Proposal for amendments to ECE/TRANS/WP.29/GRSP/2014/22

The modifications to the existing text of the Regulation are marked in bold for new or strikethrough for deleted characters. The modifications to ECE/TRANS/WP.29/GRSP/2014/22 (Proposal for the 03 series of amendments to Regulation No. 94 on Frontal collision) are highlighted in yellow. The modifications decided during this GRSP are highlighted in green.

Figure 1
Neck tension criterion

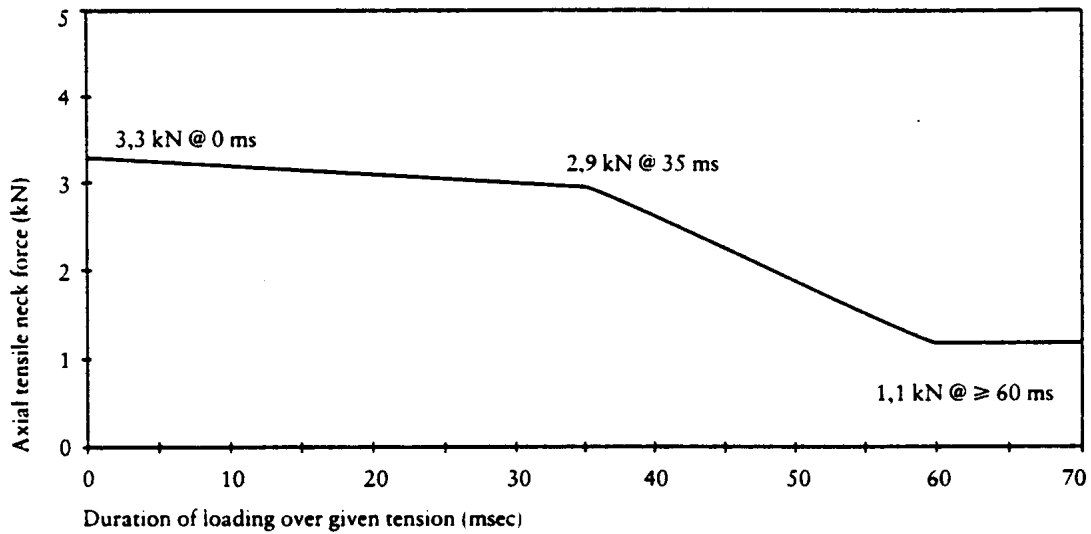
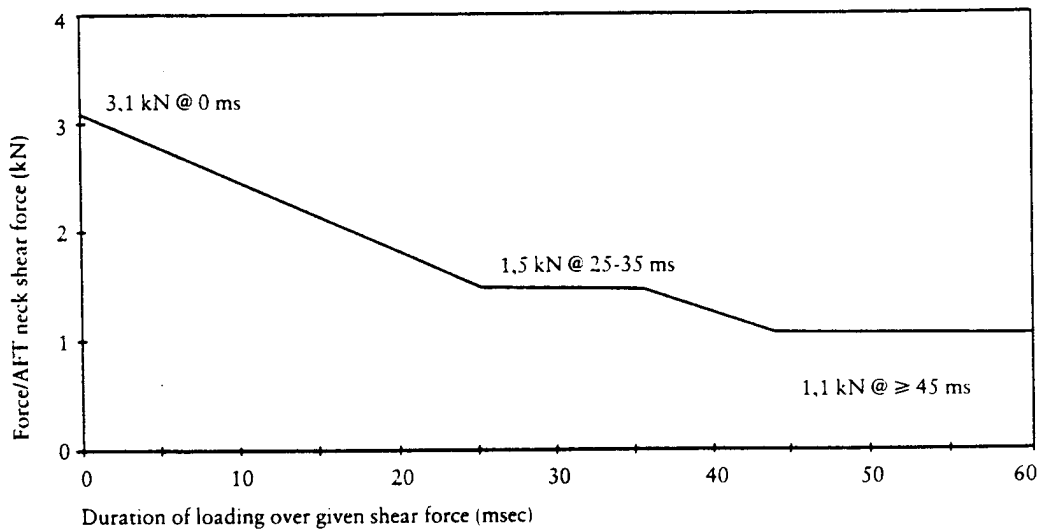
Paragraph 5.2.1.2., amend to read:

"5.2.1.2. The Neck Injury Criteria for neck (NIC) shall not exceed the values shown in Figures 1 and 2,¹ following values:

(a) ~~The axial tensile neck force shall not exceed 3.3 kN;~~

(b) ~~The fore/aft shear forces at the head/neck interface shall not exceed 3.1 kN;~~

(c) ~~The neck bending moment about the y axis shall not exceed 57 Nm in extension.~~

Model B

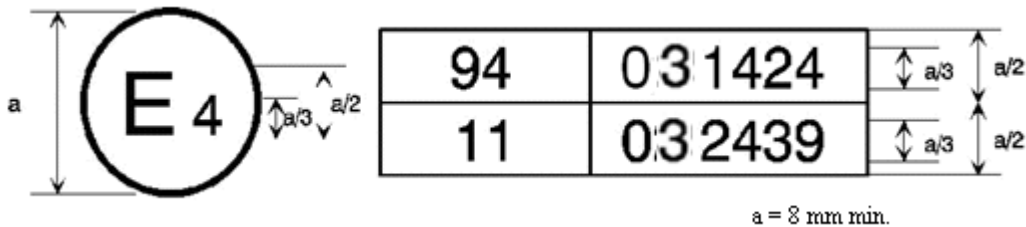
The above approval mark affixed to a vehicle shows that the vehicle type concerned has been approved in the Netherlands (E 4) pursuant to Regulations Nos. 94 and 11[†]. The first two digits of the approval numbers indicate that, at the dates when the respective approvals were granted, Regulation No. 94 incorporated the 02 03 series of amendments and Regulation No. 11 incorporated the 02 03 series of amendments."
